FEDERAL COMMUNICATIONS COMMISSION

In re: W201CN, Afton, VA
BPFT-20100304AAA
Facility ID # 93681

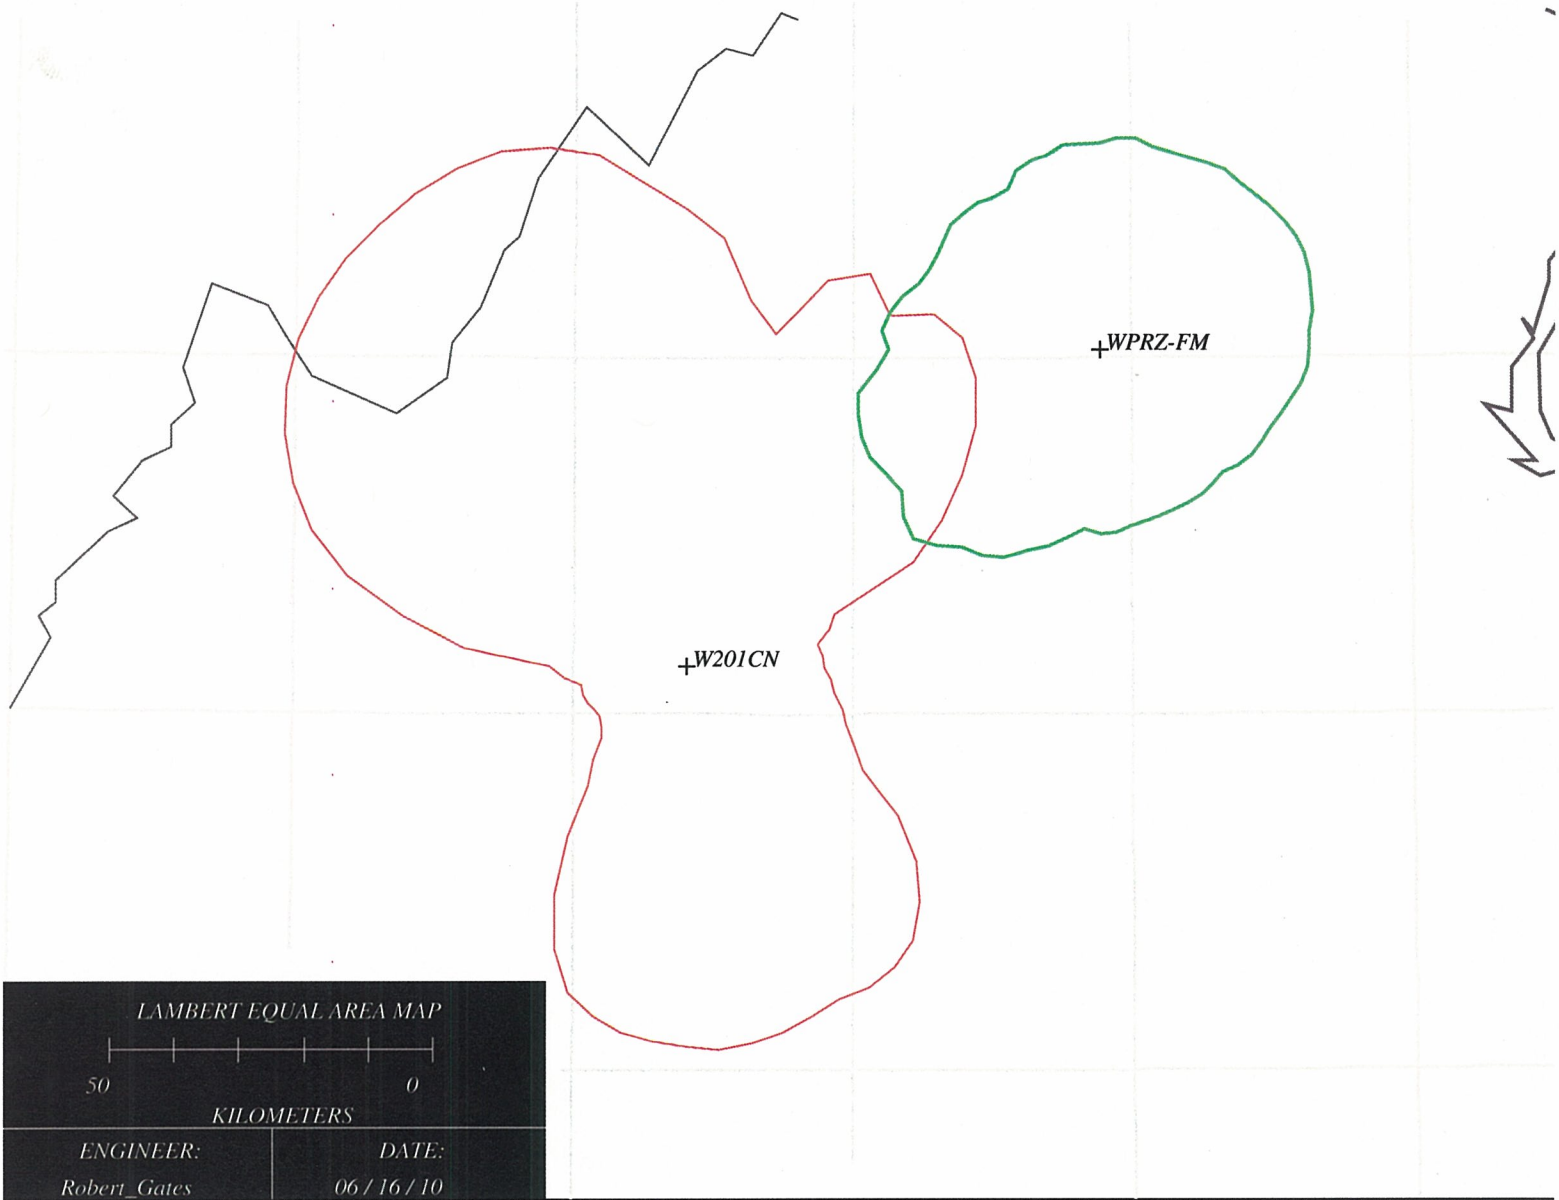
An engineering study has revealed the application violates 47 C.F.R. § 74.1204(a) with respect to WPRZ-FM, Brandy Station, VA (BMPED-20100301ABZ). Section 74.1204(a) states that an application for a FM translator station will not be accepted if the proposed operation would involve prohibited overlap of predicted field strength contours with any other authorized station. The proposed 37 dBu interference contour overlaps with the 57 dBu protected contour of WPRZ-FM.

In light of the above, the application BPFT-20100304AAA filed by Stucomm, Inc. is unacceptable for filing pursuant to 47 C.F.R. § 73.3566(a) and IS HEREBY DISMISSED. This action is taken pursuant to 47 C.F.R. § 0.283.
